From: Joseph, Stacy
Sent: Tuesday, December 28, 2010 10:24 AM
To: Thomas, George; Gilmer, James
Subject: FW: Draft 6C R1 Uploaded
Attachments: Appendix 6C Markup draft R1.pdf

6C Containment Debris Protection for ECCS Strainers

STD DEP 6C-1 (Figure 6C-1~~, 6C-2, 6C-3, 6C-4, and 6C-5~~)

~~Figure 6C-2 Core Inlet Delta-P for Blocked and Unblocked Cases~~

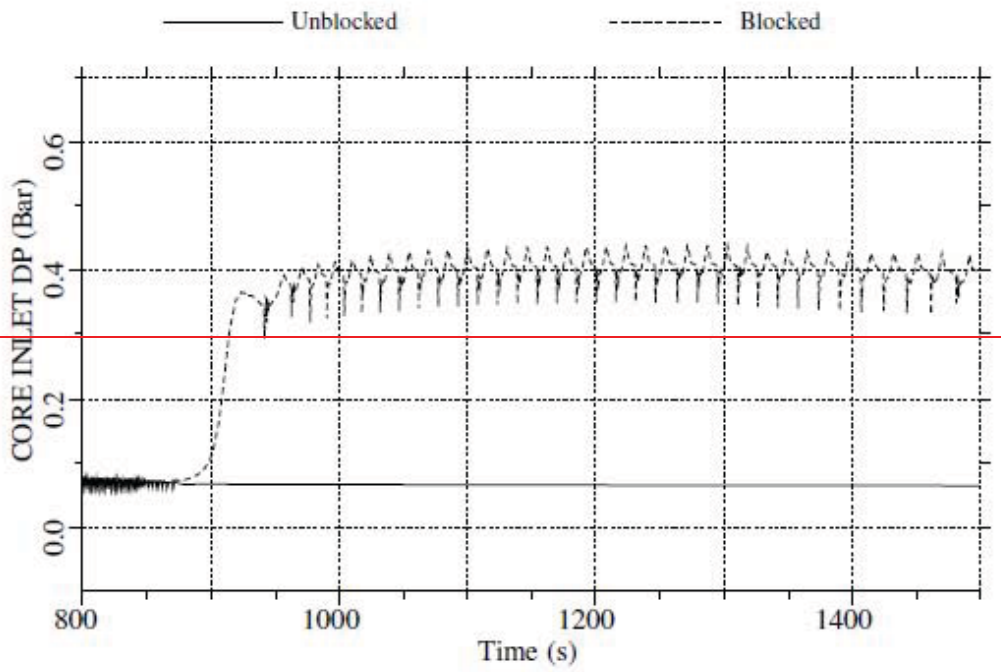
~~Figures 6C-2, 6C-3, and 6C-4~~ Analysis was performed to compare the core inlet DP, flow rate and void fractions for the cases with no blockage and with blockage resulting in ~~a reduction of flow area by 90% of inlet flow area~~ an increase of the hydraulic resistance of the fuel inlet. ~~Five minutes is the estimated amount of time required for debris in the containment to start to reach the fuel filters. The models assume clogging begins at 850 seconds because that is when the flow through the core reaches steady state. In order to ensure any effects seen are covered by the changes being made, steady state flow is required.~~ Despite a very high level of ~~blockage~~ hydraulic resistance, sufficient flow

~~Figure 6C-5. Peak Clad Temperature for Blocked and Unblocked Cases~~

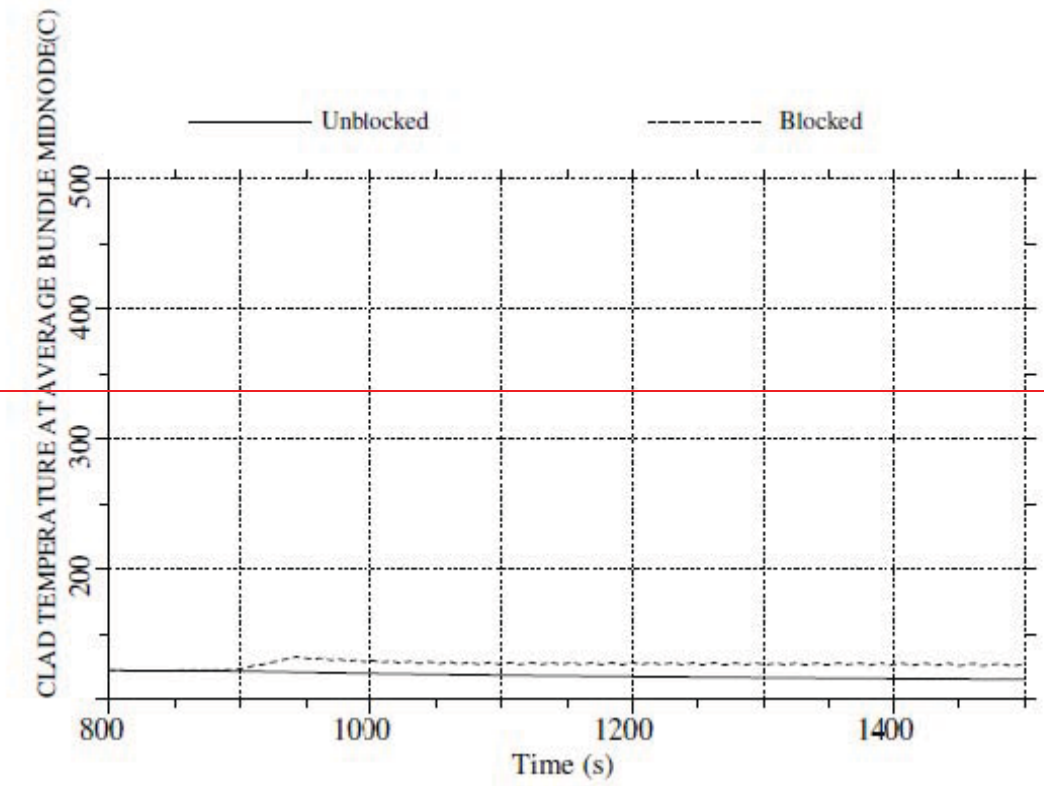
~~The impact on the clad temperature of fouling caused by an assumed deposition of particulate debris on the cladding is small. The increase in PCT from low fouling to high fouling is only approximately 30 deg F.~~ A study was performed on the effects of debris fouling on clad temperature. Normal clad fouling varies between 0.0-10.0µm; this was increased to a uniform 30µm. This increase resulted in a maximum increase in clad temperature of 30°C.
